**LEGAL ADVERTISEMENT
PORTLAND PLANNING BOARD MEETING**

Memorandum Planning and Urban Development Department Planning Division

To: Elizabeth Boepple, Chair and Members of the Portland Planning Board
From: Jean Fraser, Planner
Date: June 9, 2017
Re: Level III Master Development Plan and Level III Site Plan for Phase 1;
383 Commercial Street (Rufus Deering site) (IZ Conditional Use also submitted)
Deering Property Development, LLC, Applicant
Project #: 2017-005 CBL: 042 A001001
Meeting Date: June 13, 2017

RE: Rear Existing Retaining Wall, 383 Commercial Street

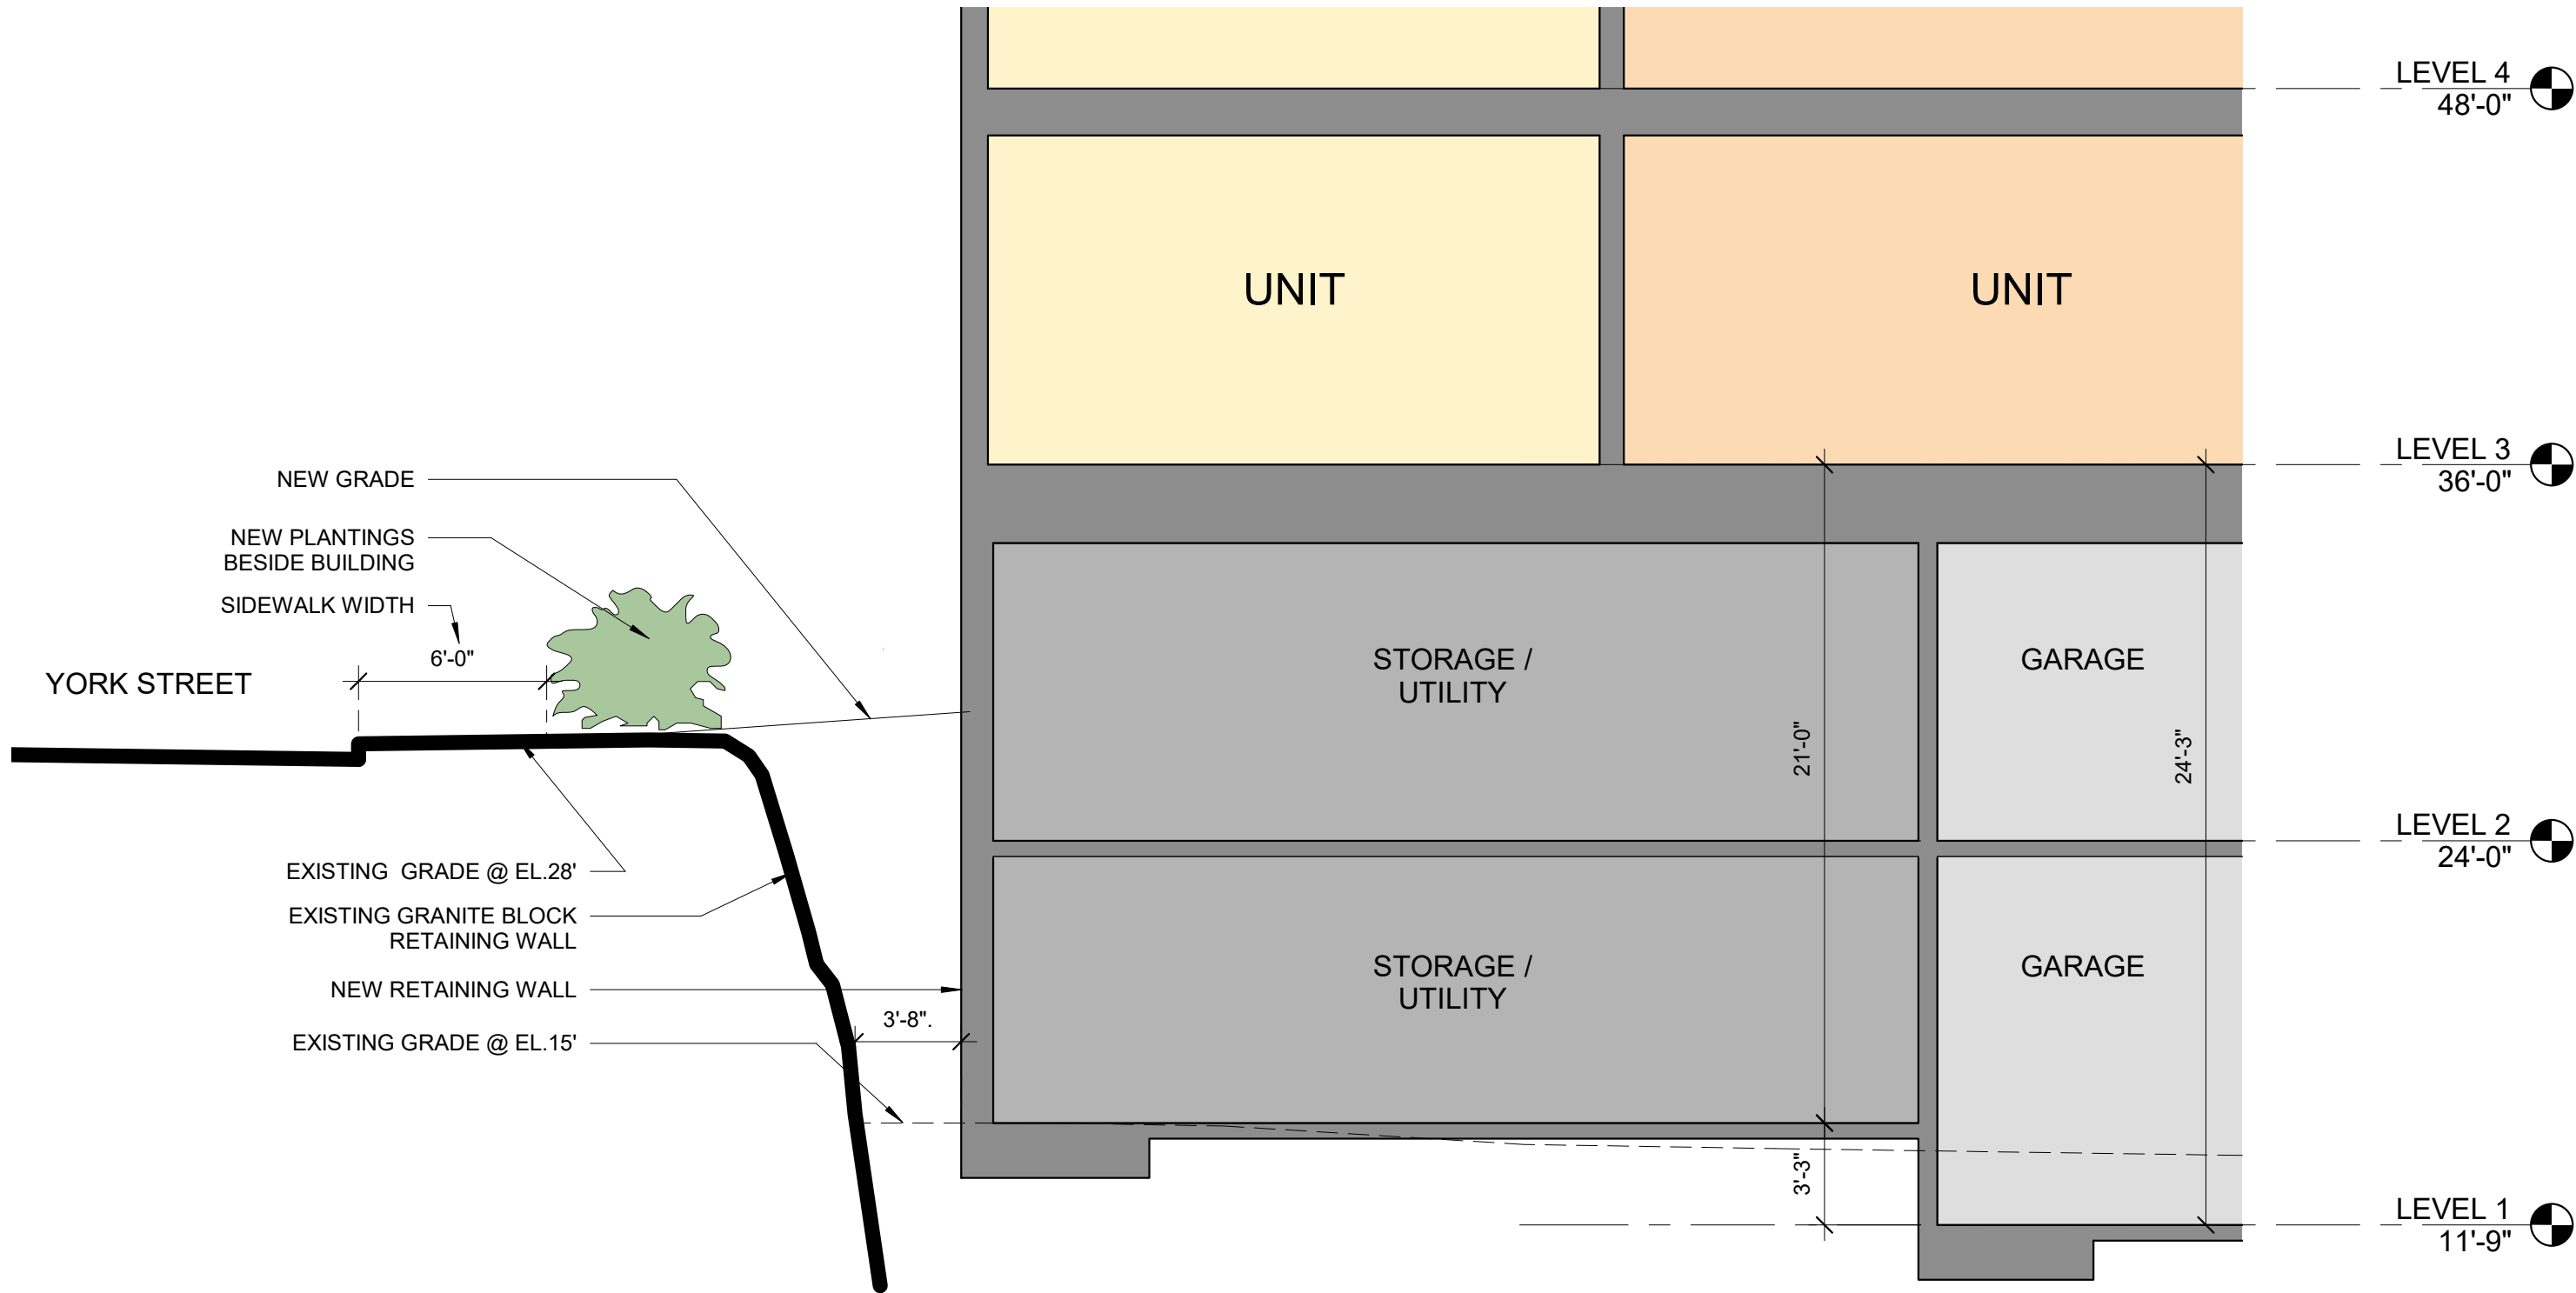
Construction Management Plan (CMP) – a CMP meeting the City’s recent “template” shall be required as part of the final submissions. Of particular concern (see Peer Engineering comments) is that the existing retaining wall along the entirety of York Street may not be stable enough to withstand the construction activities of Phase 1. The applicant has submitted a brief explanation of the way the new building walls will relate to the existing retaining wall ([Attachment Z](#)), but further geotechnical and structural engineering information should be submitted to determine what measures should be included in the Phase 1 proposals to ensure the safety and stability of the Phases 2 & 3 wall during construction of Phase 1 .

The existing retaining wall running east to west on the north side has been in place for well over 100 years. It is our intention to leave the existing retaining wall in place in its existing condition. We will build a new retaining wall approximately three feet away which will be designed to take the lateral earth loads that the present wall retains. Between the walls well-draining gravel will be placed and a footing drain will be added. The foundation of the new wall will be designed such that the capacity of the existing wall is not compromised during construction. The concept design has been reviewed by Bill Peterlein, Geotechnical Engineer and Rimas Veitas, Structural Engineer. See attached section.
